Carlisle | Wortman
ASSOCIATES, INC.

**Preliminary Site Plan/PUD Review
For
City of Northville, Michigan**

Applicant:	Hunter Pasteur Northville LLC 32300 Northwestern Highway, Suite 230 Farmington Hills, MI 48334
Project Name:	The Downs Planned Unit Development (PUD)
Plan Date:	December 15, 2021
Latest Revision:	March 22, 2022 (Sheets 7-9, and alternate row house layout) January 20, 2022 (All other information)
Location:	Vacant parcels on the south side of Cady St. (between S. Center and Griswold), the Northville Downs racetrack property south of Cady St. (between S. Center St. and River St.), and two areas on the west side of S. Center St.
Zoning:	CBD – Central Business District CSO – Cady Street Overlay District RTD – Racetrack District R-2 – Second Density Residential District
Action Requested:	Preliminary Site Plan/PUD Review – Residential/Commercial Land Use and Locations
Required Information:	As noted within this review

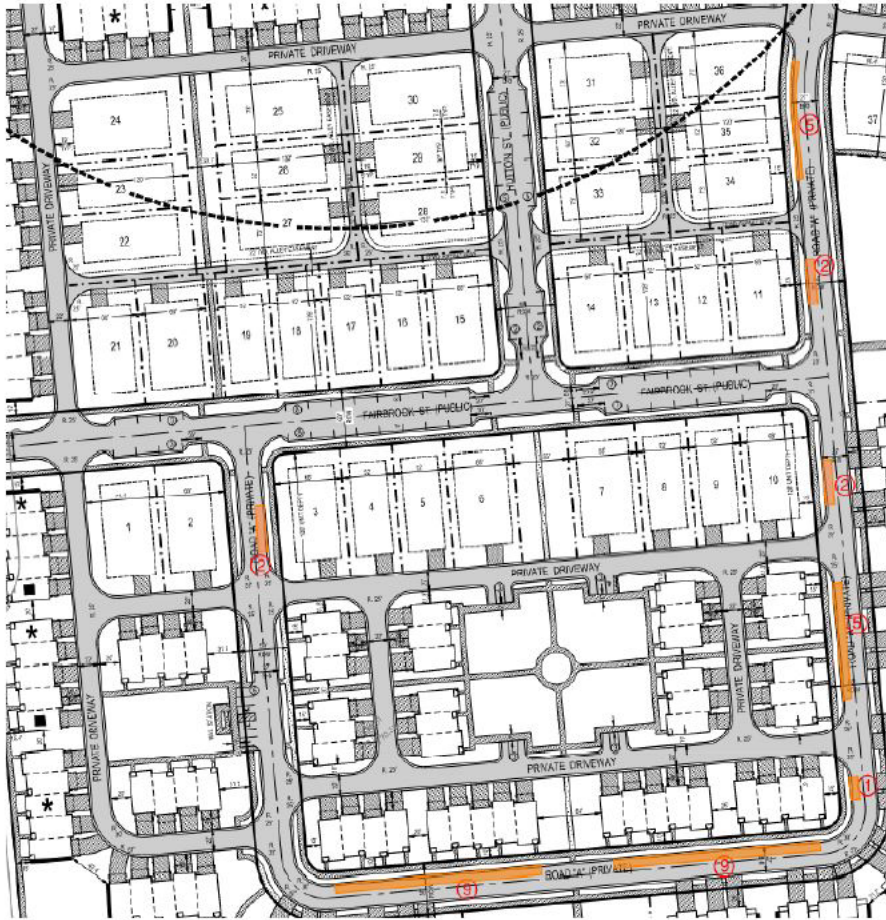
Sheets 8 and 9 of the plan set show the site’s existing topography, and provide spot elevations generally indicating how the site will be graded to accommodate the development. We defer evaluation of the proposed Grading Plan to the City Engineer.

Items to be Addressed: 1) Indicate on the tree survey trees to be removed. 2) Consider retaining trees #2401, #2403, #2415 and #2433; revise numbering to eliminate duplicate tag numbers for 2433. 3) Defer evaluation of Grading Plan to City Engineer.
